U.S. FOOD AND DRUG ADMINISTRATION MUIRKIRK ROAD CAMPUS MASTER PLAN

Final Environmental Impact Statement
Appendix B – Scoping Comments

RE: Scoping for the Proposed U.S. Food and Drug Administration Muirkirk Road Campus Master Plan Environmental Impact Statement

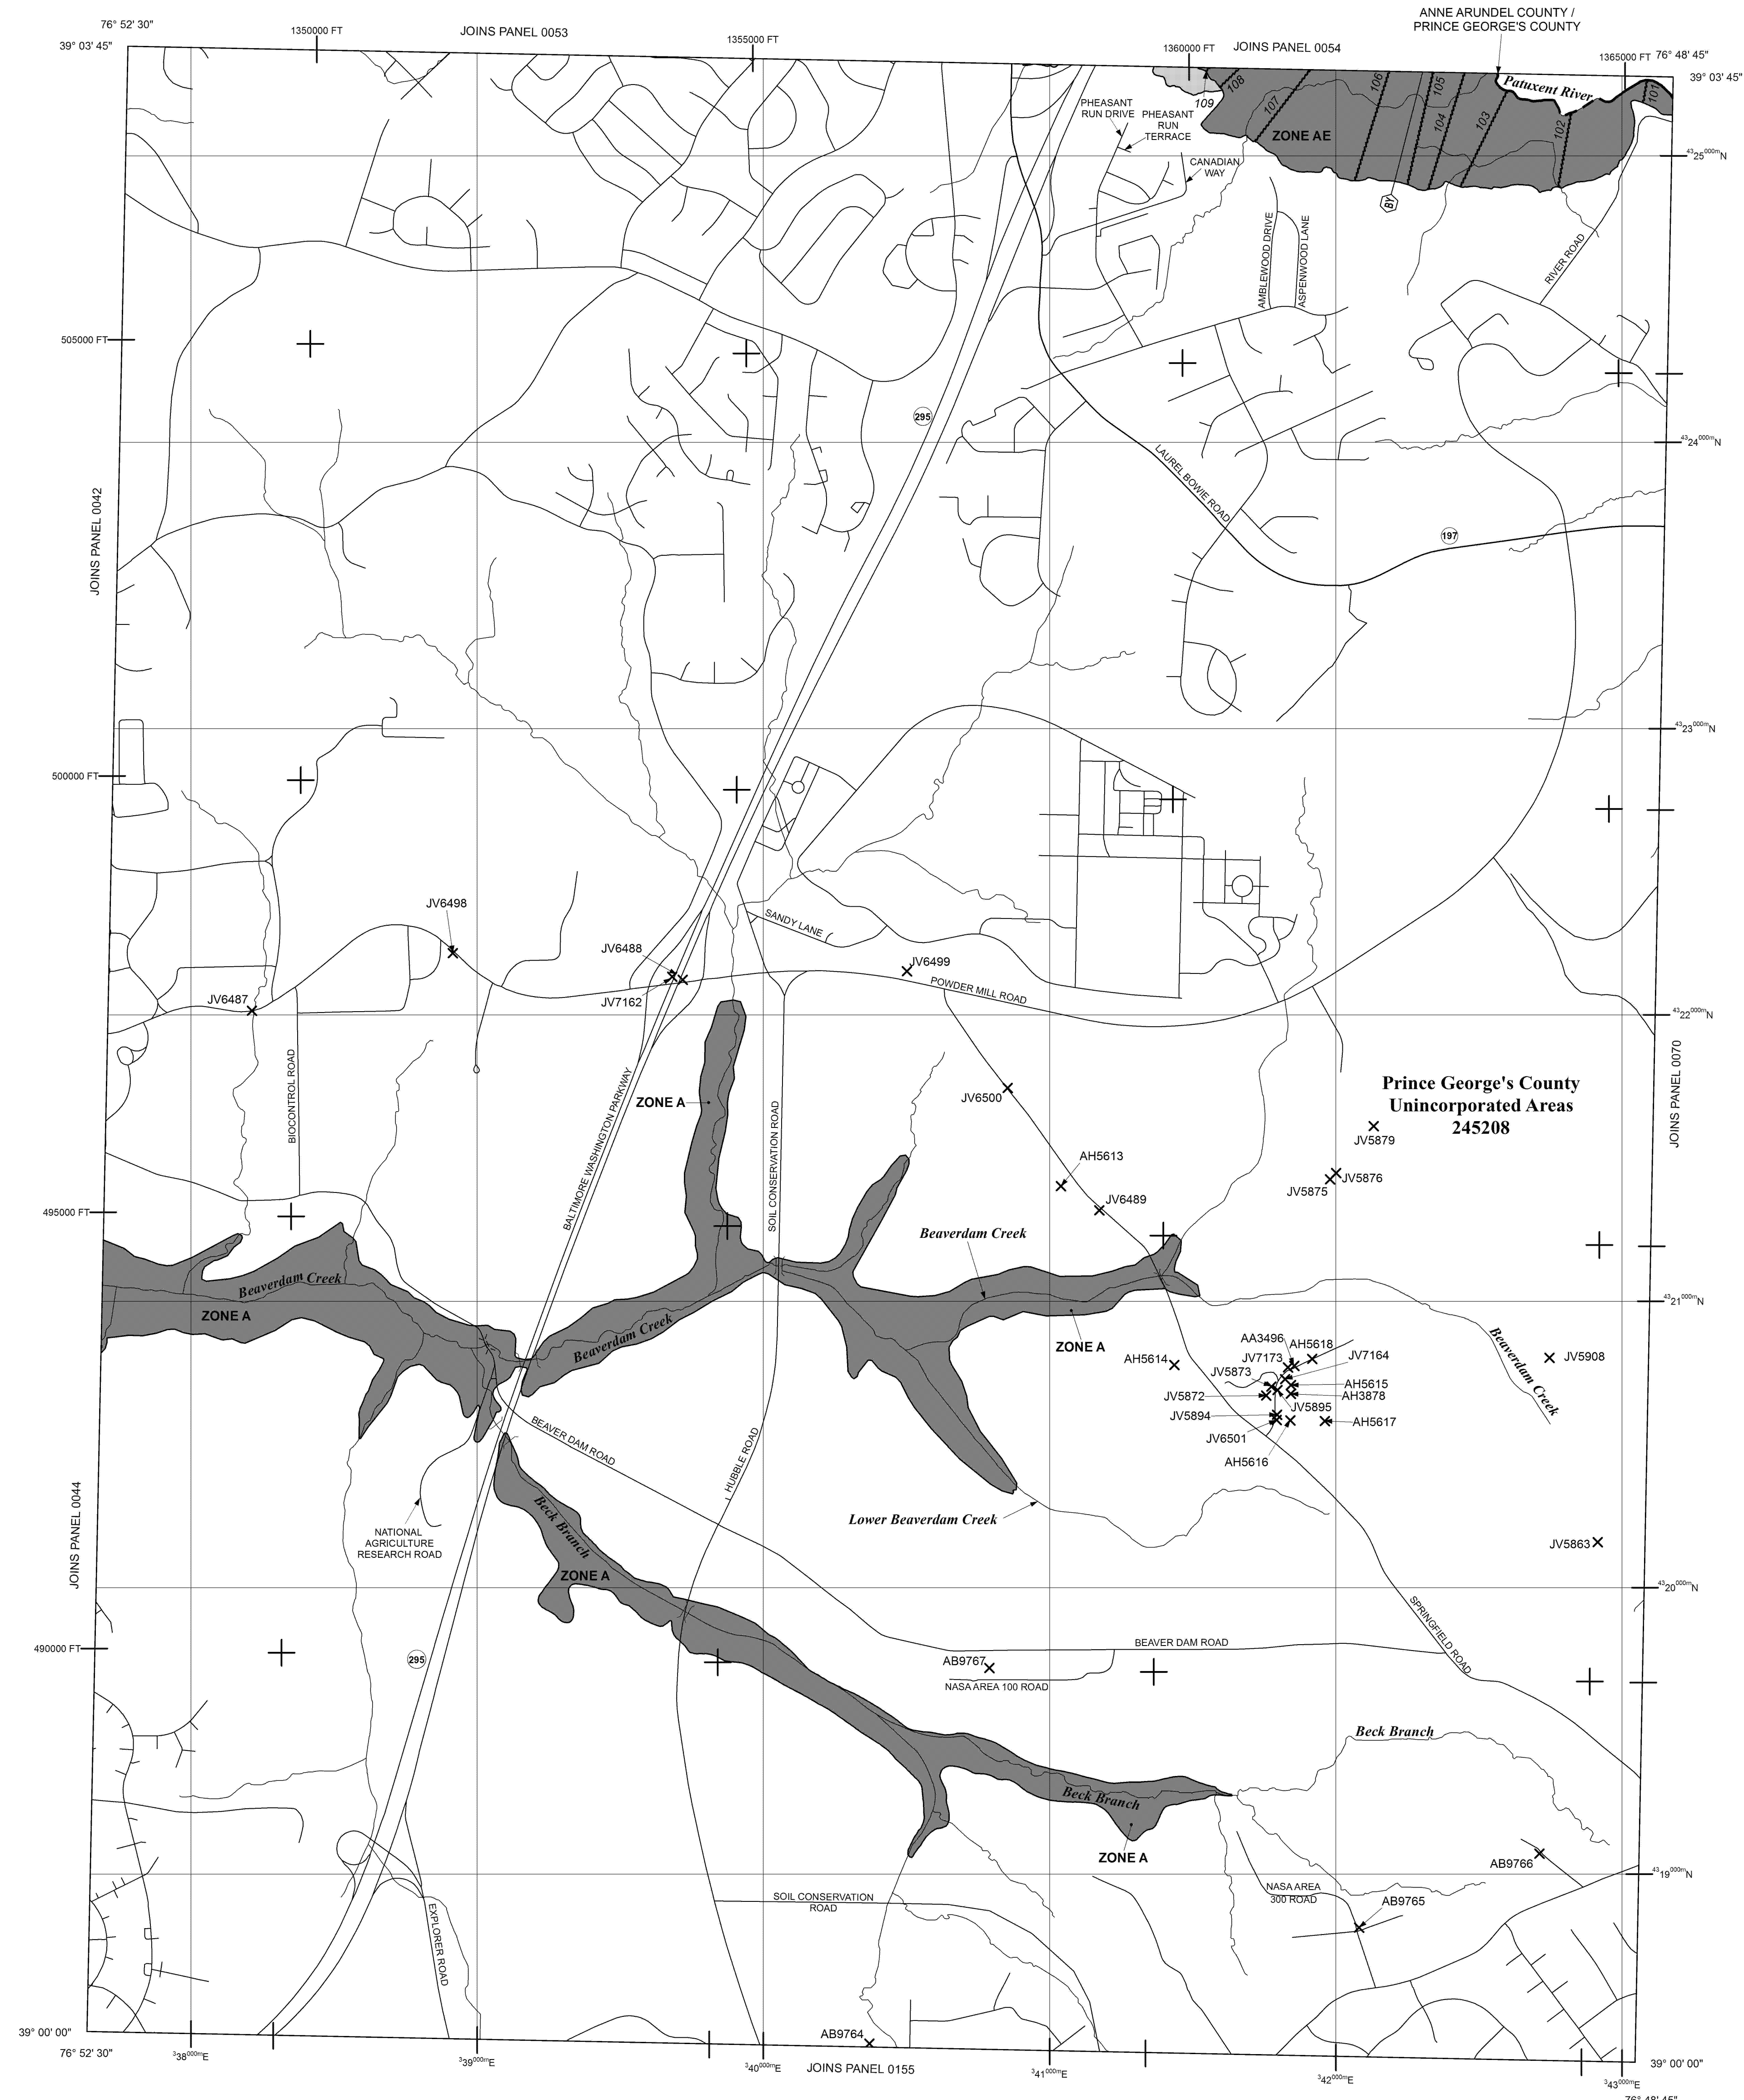
Comment: The site is out of the Special Flood Hazard Area (SFHA) shown on the effective Federal Emergency Management Agency (FEMA) Flood Insurance Rate Maps (FIRMs), panel 24033C0065E dated September 16, 2016. The Storm Water Management Technical Group Comprehensive Watershed Management Plans for the Anacostia River Watershed, dated September 1993, also show no floodplain impacts. Provided are multiple attachments which include: a copy of the FIRM panel 24033C0065E, a FEMA National Flood Hazard Layer FIRMette, and a GIS map showing Greenhorne & O'Mara Anacostia River Watershed Study 1-percent annual chance floodplain delineation.

The site plan should be reviewed by the Prince George's County Department of Permitting, Inspections, and Enforcement (DPIE) and all regulatory floodplain questions should be directed to DPIE.
